Scandex (Bd) Ltd.

6th January 2021

Observations

Plastic water tank

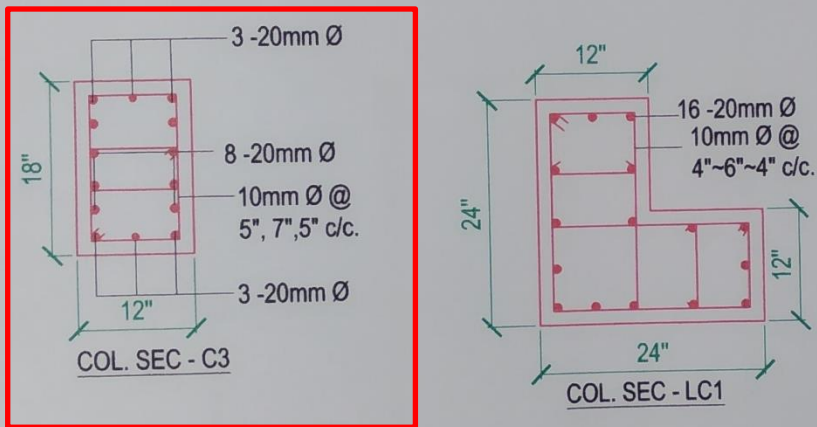
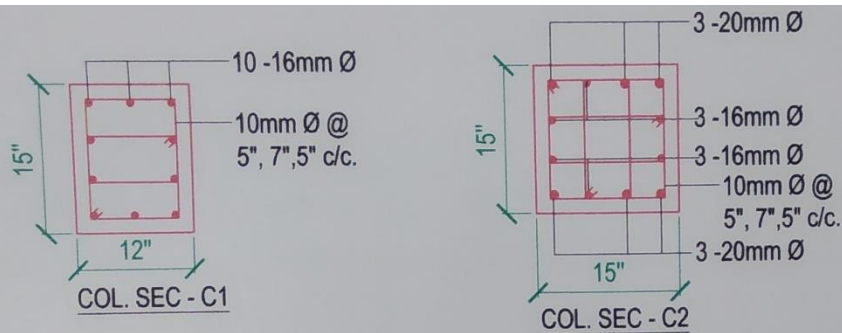
Two RCC O.H.W.T is shown in architectural drawing however 2 nos P.V.C water tanks are present at different locations.

In foundation drawing, lift core foundation has been merged with other footings. No details have been provided in drawings regarding this issue.

4 numbers of rebar in long face of C3 Column

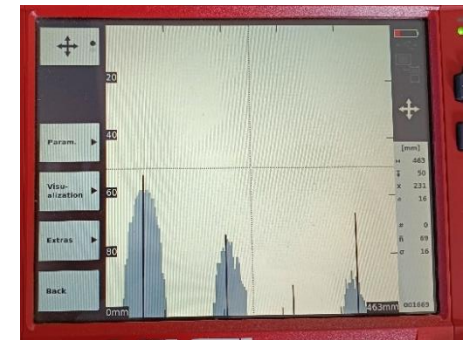
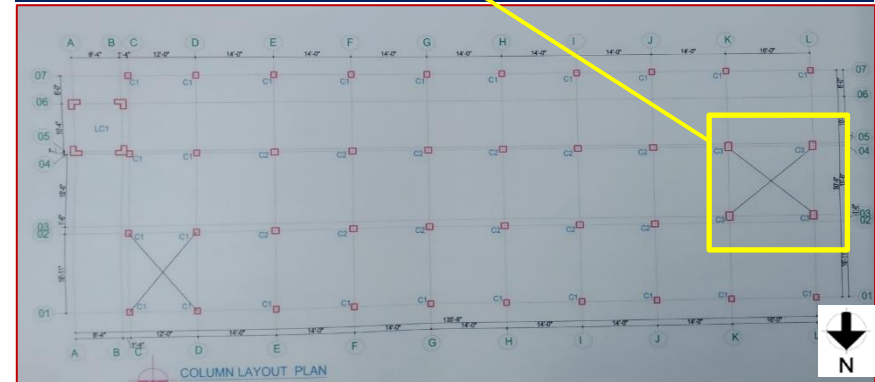
Rebar numbers of C3 column did not match with structural drawing. On long face (450 mm) 6 numbers of rebars were shown in column section, whereas 4 numbers of rebars were found by ferro scanning. Moreover, the size of the column was found different in column schedule.

Inverted beam on site

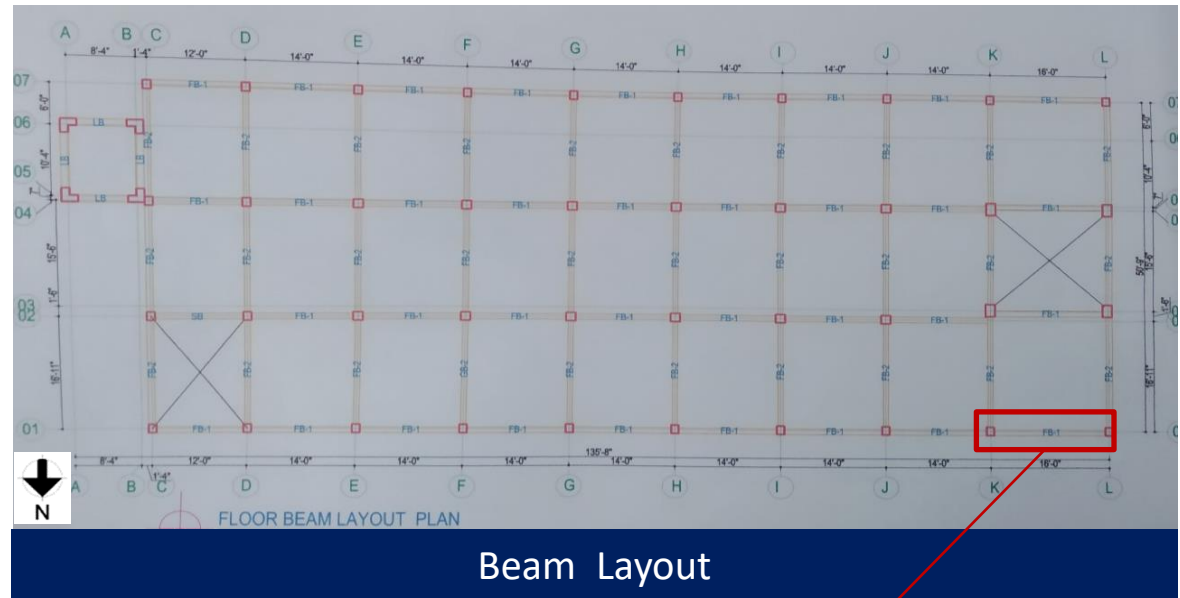
There is an inverted beam on ground floor roof level of grid 1/K-L which is not mentioned in as built drawing.

Existing cylinder test report (3rd phase)

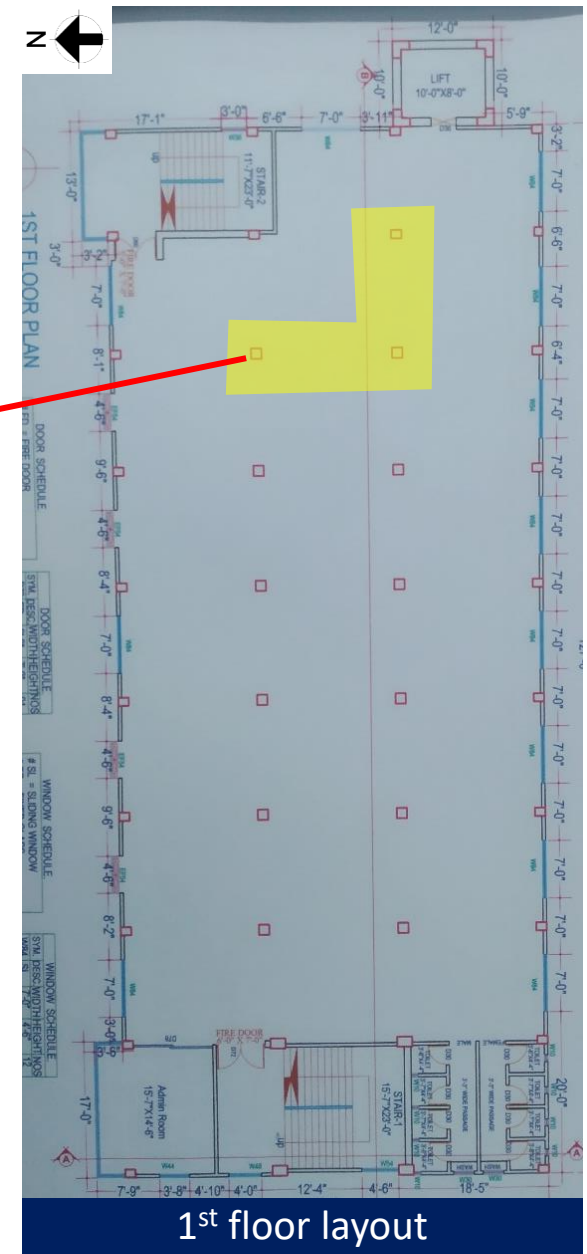
No load plan has been prepared for the production building, besides localized high loading surrounding the column was observed in 1st floor. Moreover, in sufficient concrete test report was found for 2nd phase of construction. No test report found for 1st phase of construction.

As per BNBC every building or structure designed shall have its design documents prepared in accordance with the provision of Section 1.9.1. The design document shall include a design report, and a set of structural drawings, which shall be prepared in compliance with section 1.9.1.1 and section 1.9.1.2 as per BNBC. During the inspection, the design report has not been found which is required to be prepared in compliance with section 1.9.1 (part-6, BNBC).

Non engineered connections

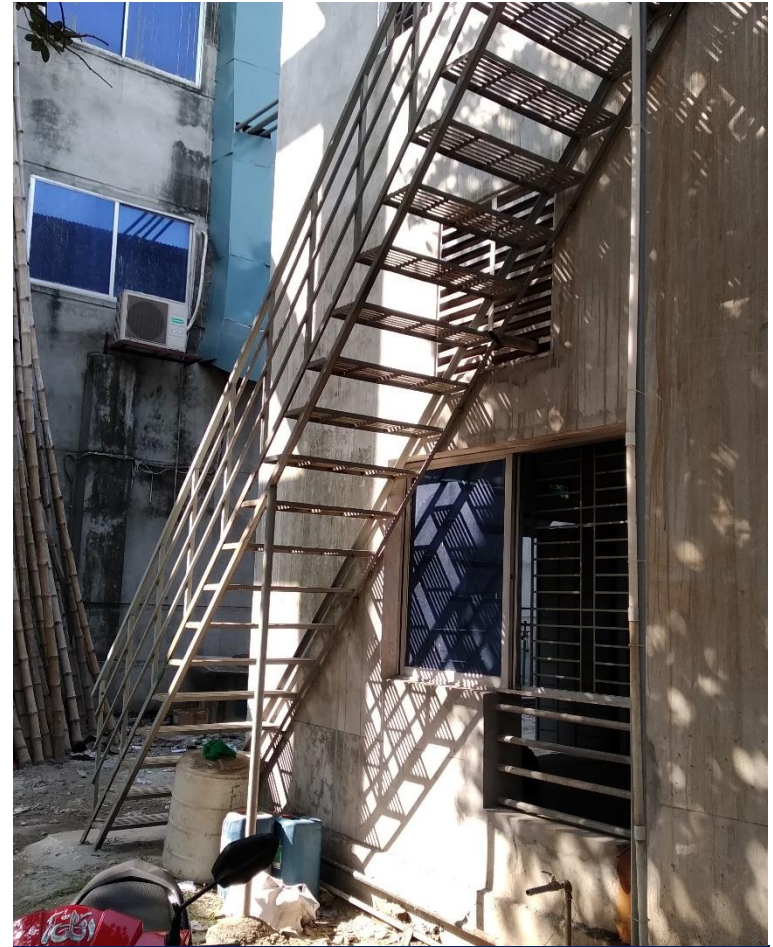
Apparently inadequate steel member size and no stability system provided.

Factory engineer is required to carry out the member adequacy & stability and implement remediation where required.
